AGENDA

CITY OF KETCHUM
MEETING MINUTES OF THE
SPECIAL JOINT MEETING
CITY COUNCIL & PLANNING AND ZONING COMMISSION
Tuesday February 14, 2023

LANDSCAPE PLAN
RESIDENCE
691 N. SPRUCE AVE, KETCHUM, IDAHO

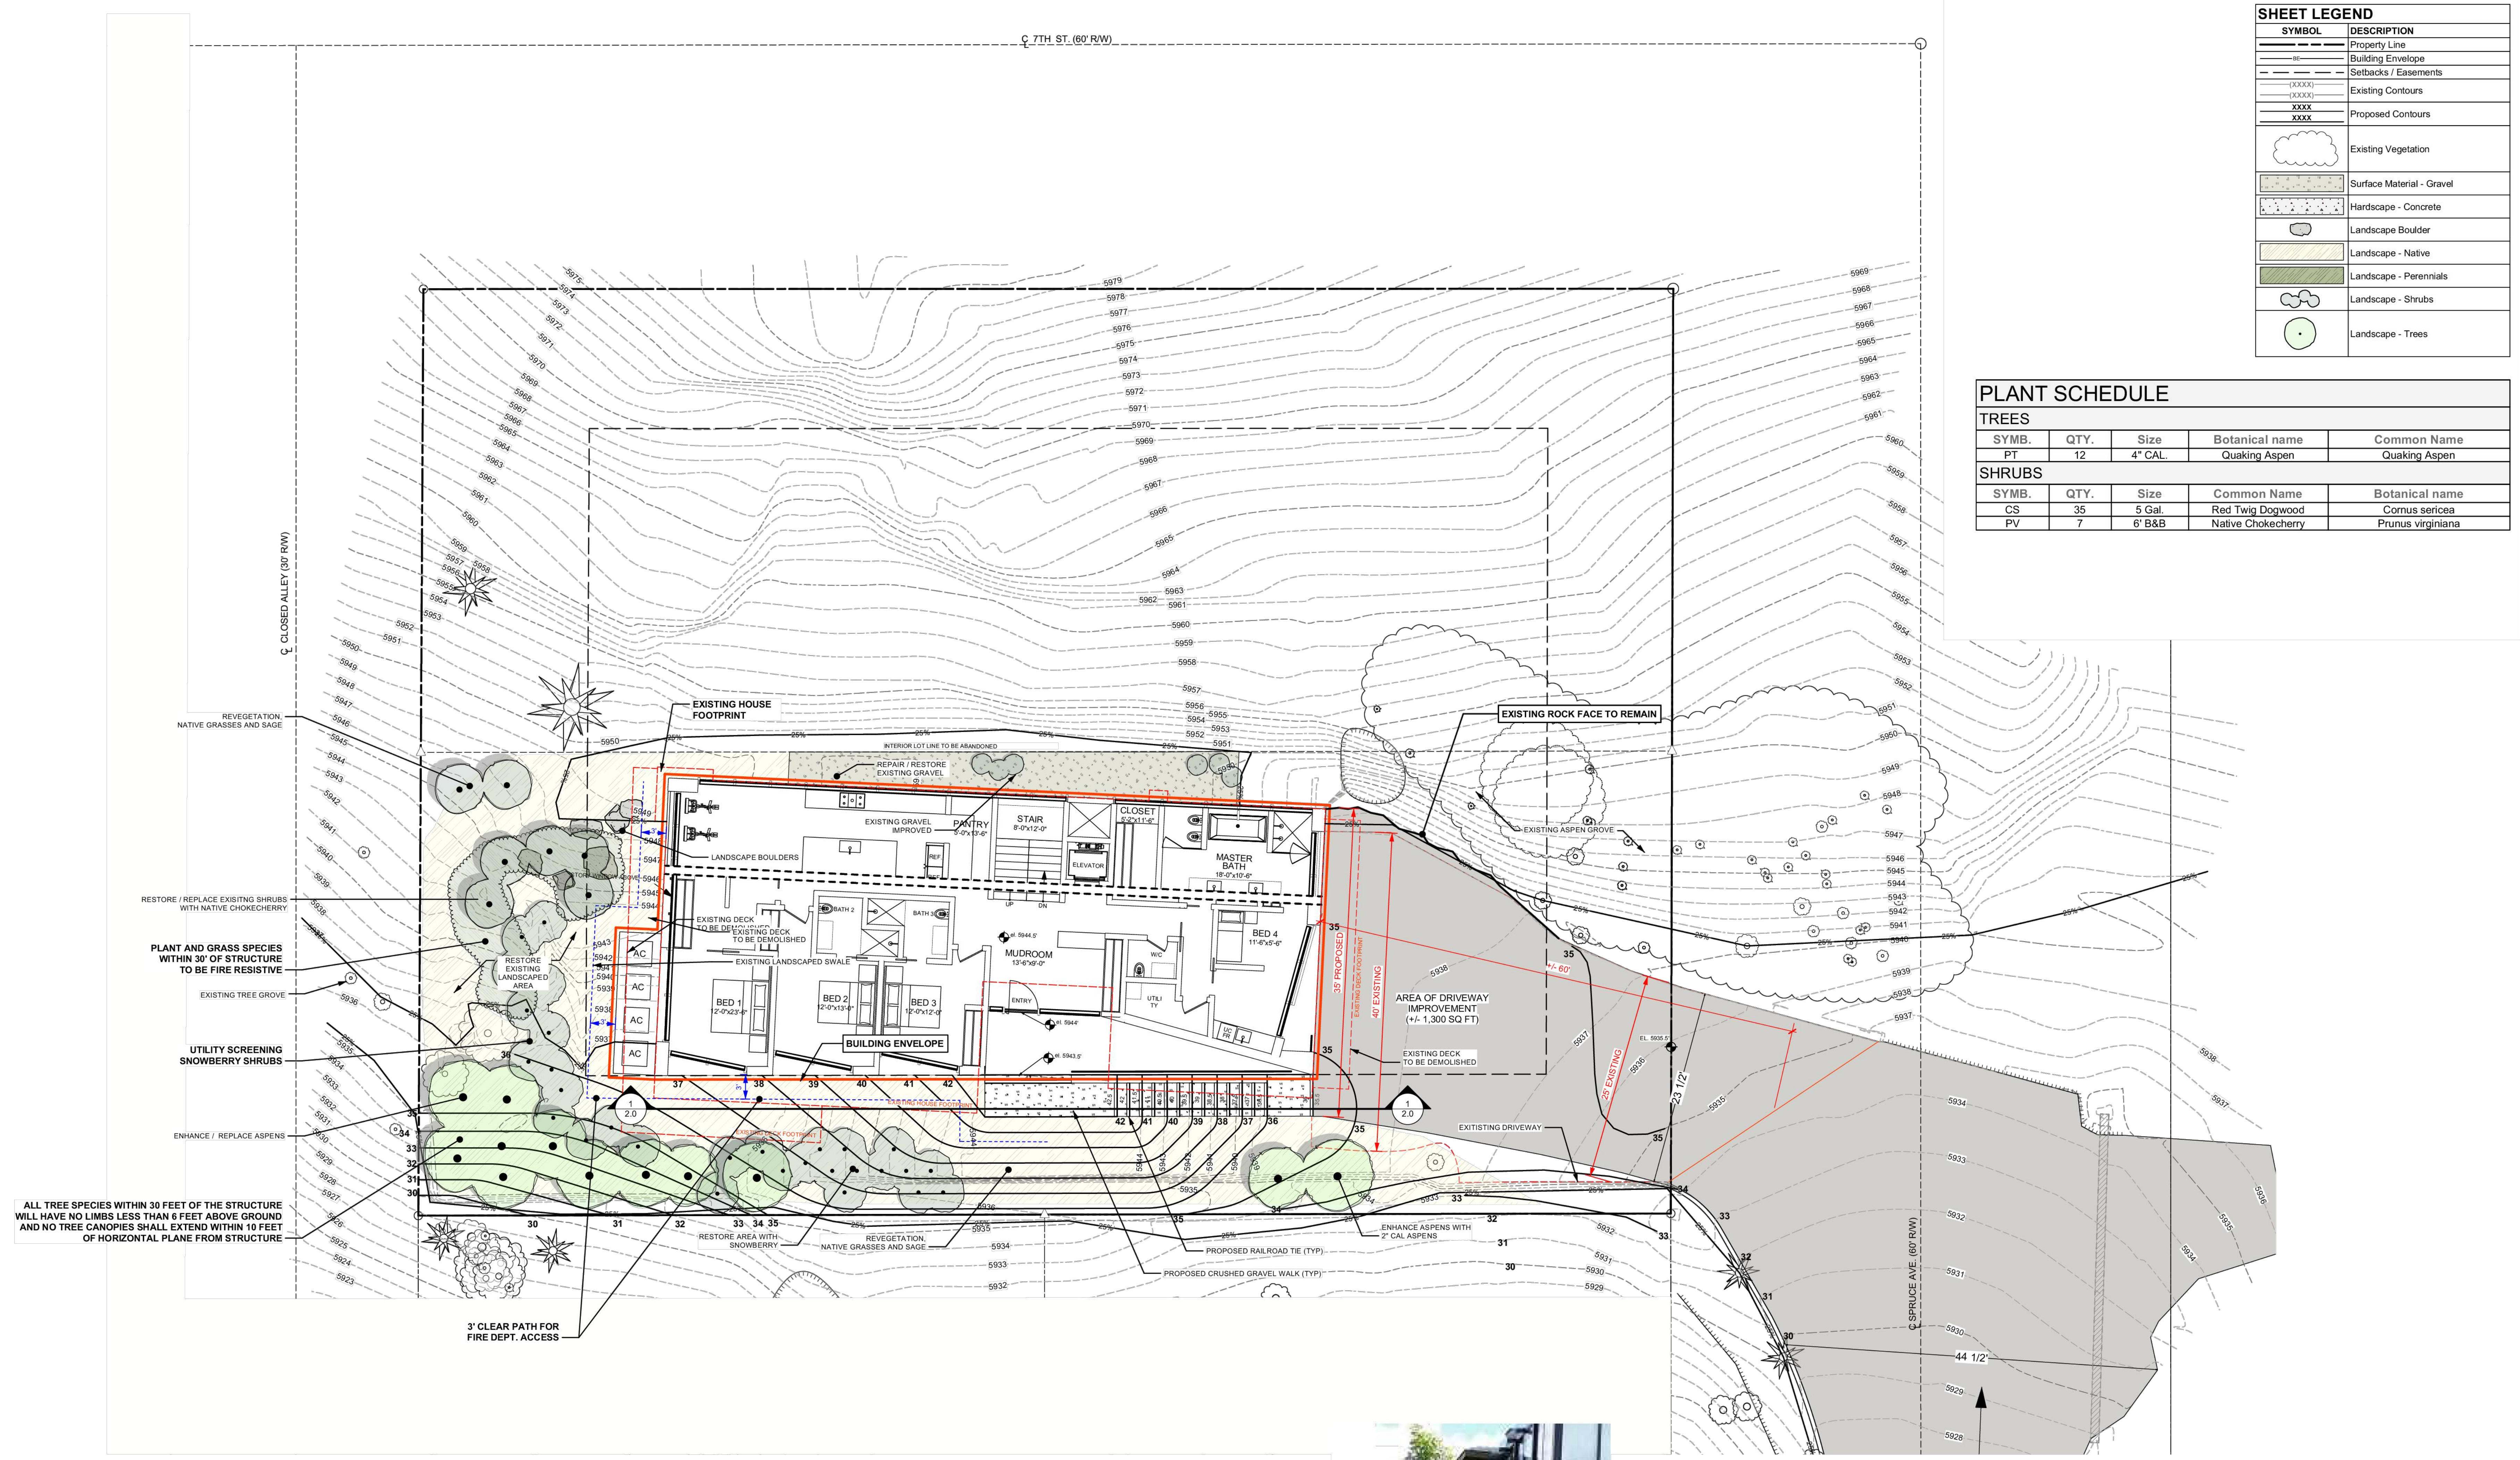
4. Comment: The landscape plan on Sheet L2.0 specifies that the driveway will include a snowmelt system. In addition, Sheet L2.0 shows that two snow storage areas will be provided on site and includes a note stating that snow will be hauled off site if needed. The engineered plans on Sheets C1.1 and C1.2 show that a new asphalt driveway will be constructed. The civil drawings do not specify that the driveway will include a snowmelt system. Per our phone conversation on January 5th, 2023, the driveway will include a snowmelt system. Pursuant to Ketchum Municipal Code §17.96.060.H4, snowmelt is permitted in lieu of providing snow storage areas on site. The on-site snow storage areas and snow hauling are not required as the driveway is proposed to include a snowmelt system.

- Required Action: Please resolve the discrepancy between the civil and landscape drawings and revise the civil plans to specify the location and dimensions of the heated driveway area and snowmelt system. As on-site snow storage areas and snow hauling are not required per Ketchum Municipal Code §17.96.060.H4, Staff recommends that you remove these from the snow storage plan indicated on Sheet L2.0.

8. **Comment:** The landscape plan on Sheet L2.0 includes a picture illustrating the design concept proposed for the entry stairs. The picture shows stone treads separated by grass. The entry stairs proposed for the project are comprised of railroad ties that form risers along a gravel pathway.

- **Staff Recommendation:** Staff recommends that you add a note to Sheet L2.0 clarifying that the picture is an illustrative example of the design concept to minimize confusion for the public and Planning and Zoning Commission.

The snow storage areas and snowmelt system indicated on the landscape plan have been removed. See sheet L2.0 by BYLA.
